# **Pentium<sup>®</sup> II Processor Specification Update**

Release Date: December 1998

Order Number: 243337-021

The Pentium<sup>®</sup> II processor may contain design defects or errors known as errata which may cause the product to deviate from published specifications. Current characterized errata are documented in this Specification Update.

Figure 1. UP Dual Ended Termination (DET)

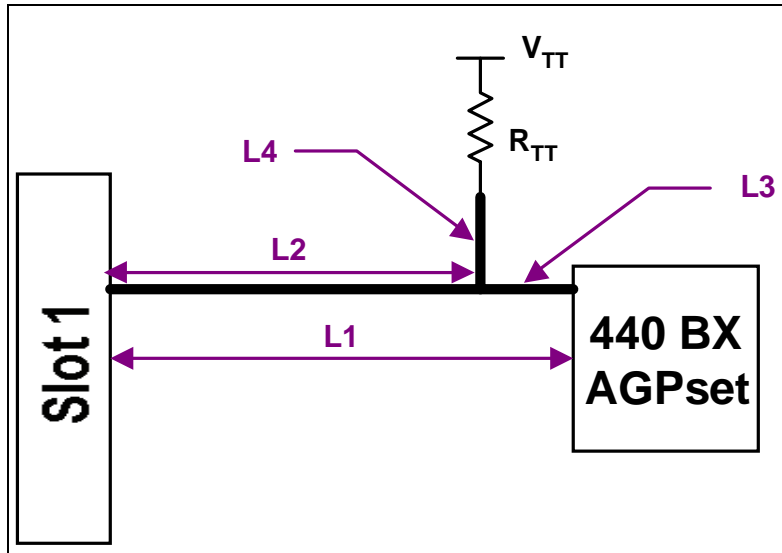
**IMPLICATION:** This violation of the bus exchange protocol when using a reduced arbitration latency may cause a system-level setup timing violation on the address, address parity, request command, or request parity signals on the system bus. This may result in a system hang or assertion of the AERR# signal, causing an attempted corrective action or shutdown of the system, as the system hardware and software dictate. The possibility of failure due to the contention caused by this erratum may be increased due to the processor's internal active pull-up of these signals on the clock after the signals are no longer being driven by the processor.

**WORKAROUND:** If the chipset and third party agents used with the Pentium II processor do not optimize their arbitration latency as described above, no action is required. For the 66 MHz Pentium II processor, no action is required. If agents that have implemented this optimization, by following the *100 MHz GTL+ Layout Guidelines for the Pentium® II Processor and Intel 440BX AGPset* for UP-SET (single-ended termination) and DP with both processors installed, no action is required. The following two cases are additional guidelines for UP-DET (dual-ended termination) and DP-DET with only one processor populated.

For UP-DET topologies (see Figure 1), the trace length L1 must be between 1.5" to 4.5" while using a 56Ω termination resistor.

Figure 23. Processor with an Example Low Profile Heatsink Attached Using Spring Clips

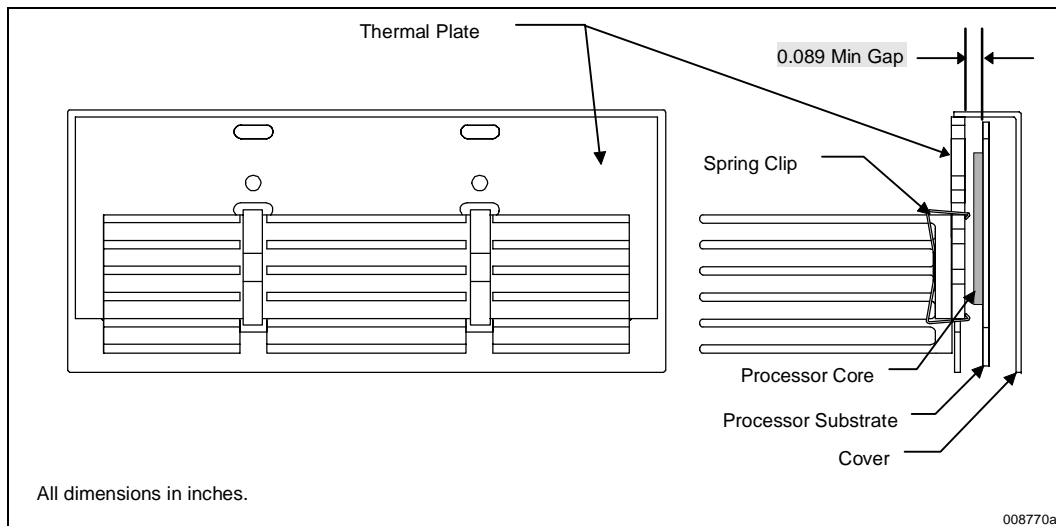
Figure 23 and Figure 24 illustrate example clip designs to support a low profile and a full height heatsink, respectively. The clips attach the heatsink by engaging with the underside of the thermal plate. The clearance of the thermal plate to the internal processor substrate is a minimum **0.089"** (illustrated in Figure 23 and Figure 24). The clips should be designed such that they will engage within this space, and also not damage the substrate upon insertion or removal. Finally, the clips should be able to retain the heatsink onto the thermal plate through a system level mechanical shock and vibration test. The clips should also apply a high enough force to spread the interface material for the spot size selected.

**Figure 6. BCLK to Core Logic Offset**

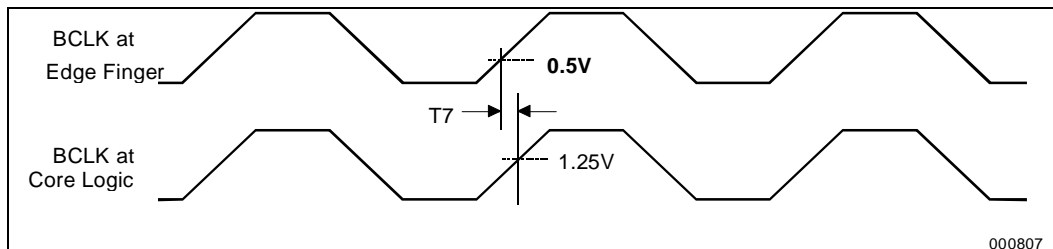
In Figure 6 of the *Pentium® II Processor at 233 MHz, 266 MHz, 300 MHz, and 333 MHz* datasheet, the following changes should be made:

**Figure 7. BCLK\*, PICCLK, and TCK Generic Clock Waveform**

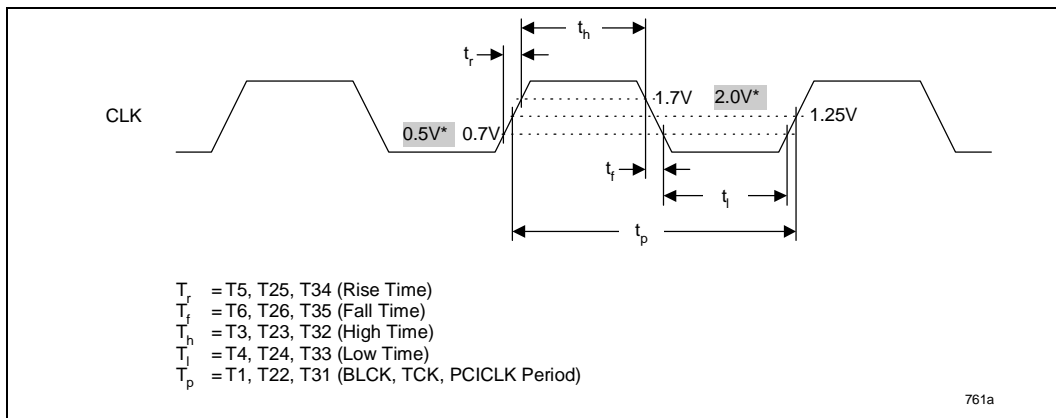
In Figure 7 of the *Pentium® II Processor at 233 MHz, 266 MHz, 300 MHz, and 333 MHz* datasheet, the following changes should be made:
